**AMENDMENTS TO THE DRAWINGS**

Application No. 10/620,489  
Docket No. 15436.441.5  
Reply to Office Action mailed March 17, 2005

Fig. 1A

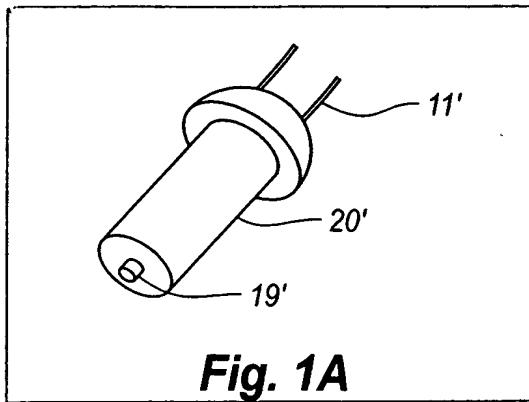
Please replace Figure 1 of the drawings with the attached Figure 1 and Figure 1A 'Replacement Sheet.' A redline markup is also enclosed that denotes the changes made to Figure 1. No new matter is believed to be introduced in the aforementioned Figure 1 and Figure 1A 'Replacement Sheet.'

The Examiner has objected to the drawings under 37 CFR 1.83(a) stating that the drawings "fail to show 'the fiber tip' that is 'extending out from the optical fiber ferrule' as claimed in claims 25-26."

In this regard, M.P.E.P. § 608.01(l) states, "In establishing a disclosure, applicant may rely not only on the description and drawing as filed but also on the original claims if their content justifies it." (emphasis added). In this case, original claims 25 and 26 as filed each recite "the fiber tip is a portion of an optical fiber extending out from the optical fiber ferrule." Consistent with the foregoing, Applicants have herein amended the figures by adding Figure 1A showing a fiber tip extending out from the optical fiber ferrule. Applicants have also herein amended the paragraph beginning on line 21 of page 10 and ending on line 21 of page 11 of the specification to recite that "end 19 of optical fiber 11 may be configured like end 19' of optical fiber 11' extending out from ferrule 20', as shown in Figure 1A."

In light of the amendments to the specification herein, Applicants respectfully submit that the objection should be withdrawn. Applicants further submit that, consistent with M.P.E.P. § 608.01(l), no new matter is entered as a result of the aforementioned amendments to the figures and the specification.
